Rehabilitation of Mount Auburn Street

A Complete Streets Project

City of Watertown
Bicycle and Pedestrian Committee
Project Update
May 2, 2022

To: Carrie Lavelle, PE
Acting Chief Engineer, MassDOT
10 Park Plaza, Suite 6340
Boston, MA 02116
Attn: Project Management, Project No. 607777
From: Watertown Bicycle and Pedestrian Committee
Date: December 6, 2021
RE: Mt. Auburn Street, Watertown, Project # 607777

WEST SIDE, BARRIER FOR BICYCLE CONNECTIVITY

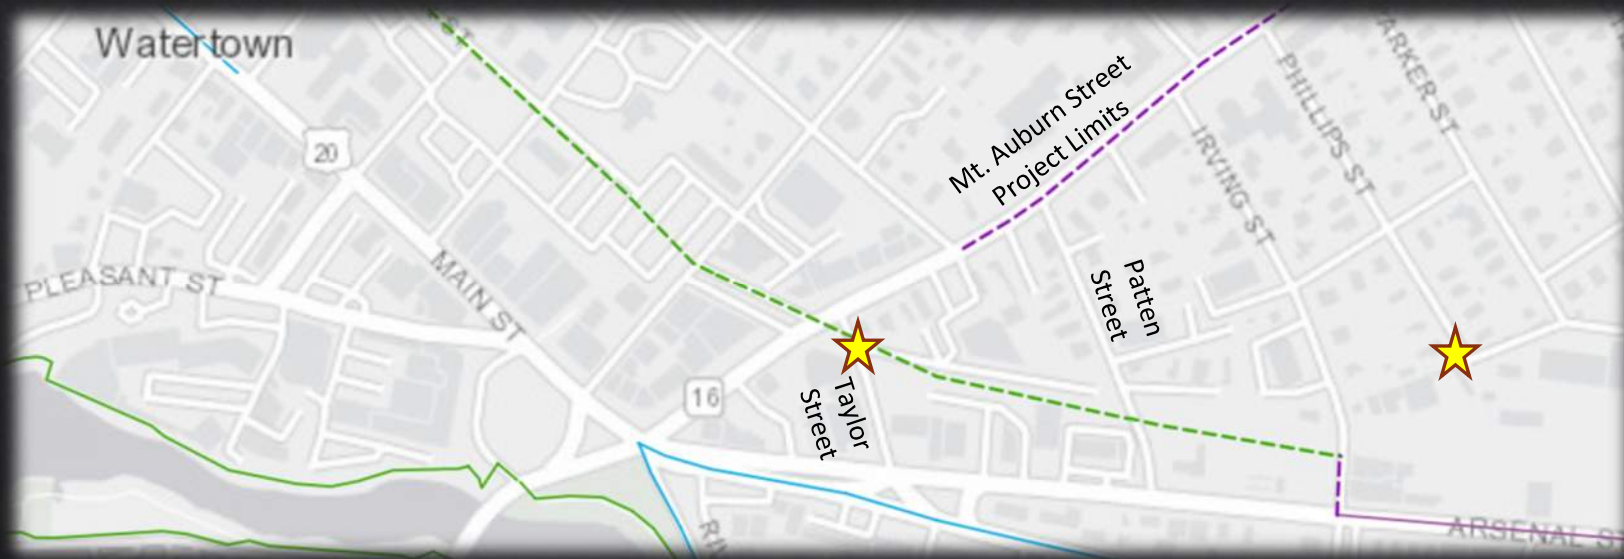
COMMENT 5

- Project approved at regional level in 2014
 - Limits defined as part of the process
 - Prior to 25% Design / Watertown-Cambridge Greenway
- Connections to Community Path (outside project limits)
 - End of Phillips Street
 - Taylor Street

COORDINATION WITH CAMBRIDGE - CONNECTIVITY

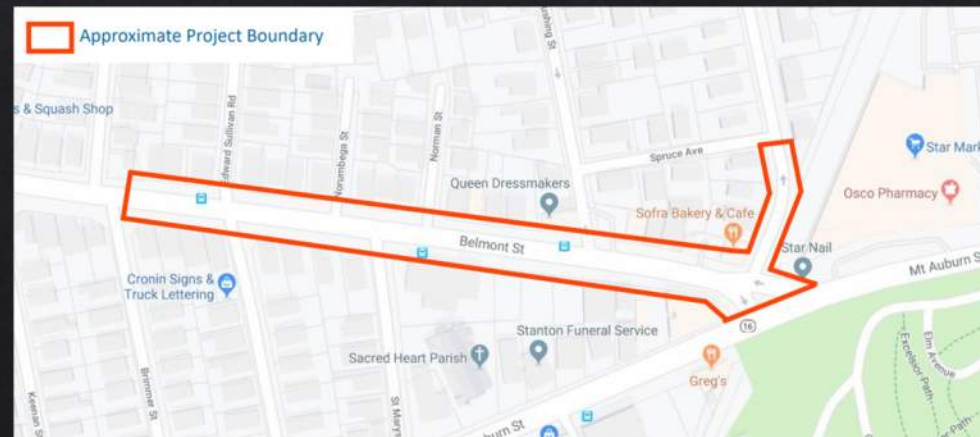
COMMENT 6

- Project team working closely with City of Cambridge
- Confirmed separated bicycle lanes part of Bicycle Plan
 - Detailed design yet to begin
 - No schedule for implementation
- Improvements on Belmont Street (Cambridge)
 - Includes Mount Auburn Street intersection
 - Roadway and sidewalk reconstruction
- **DCR installed wayfinding signage on Mount Auburn Street**
 - Directs pedestrians / bicycles to Cottage Street access
 - Additional access on Holworthy Street (Cambridge)

RAISED CROSSWALKS AT LOW TRAFFIC SIDE STREETS

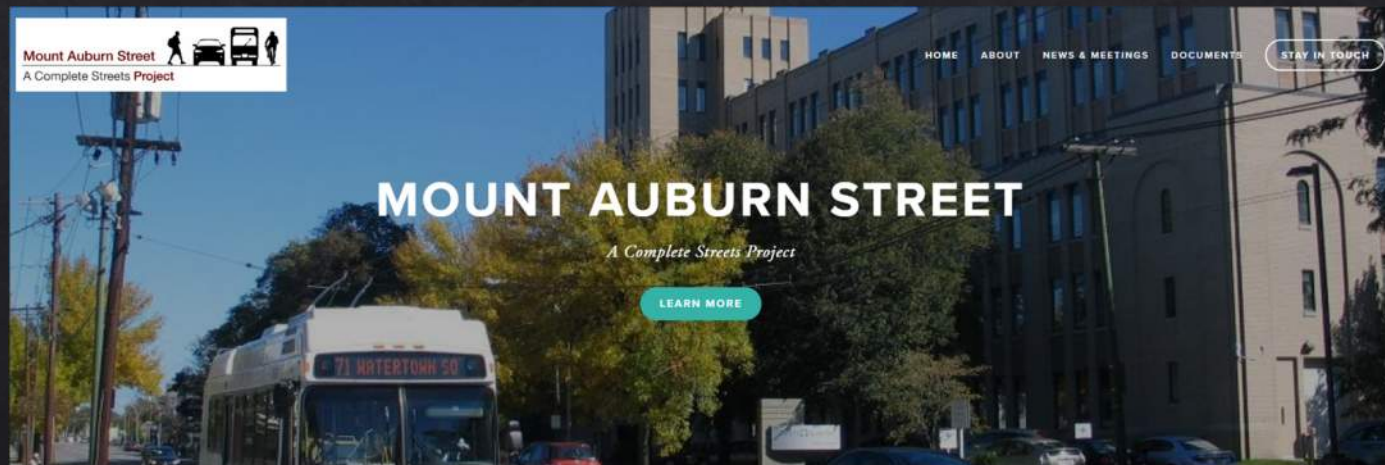
COMMENT 9

- Design team considering raised crosswalks
 - At select locations
- Follow project for future updates on this topic
 - Project website / mailing list

CROSSWALK STRIPING

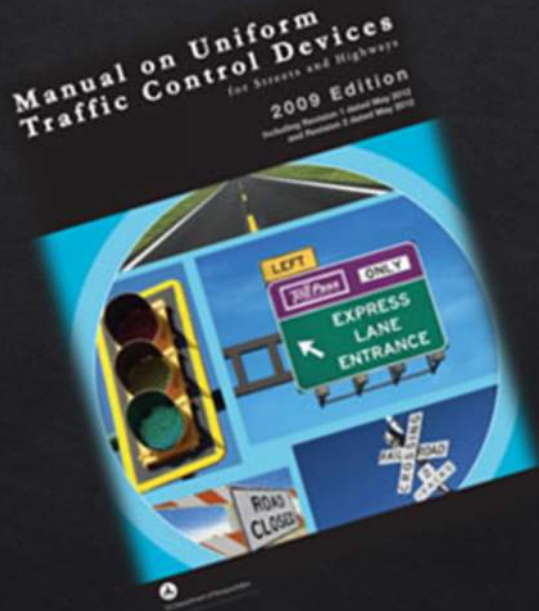
COMMENT 10

- City of Watertown standard
 - Ladder style crosswalk
 - Default configuration along corridor
 - Considered high visibility crosswalk
 - Line width and spacing in accordance with MUTCD standards
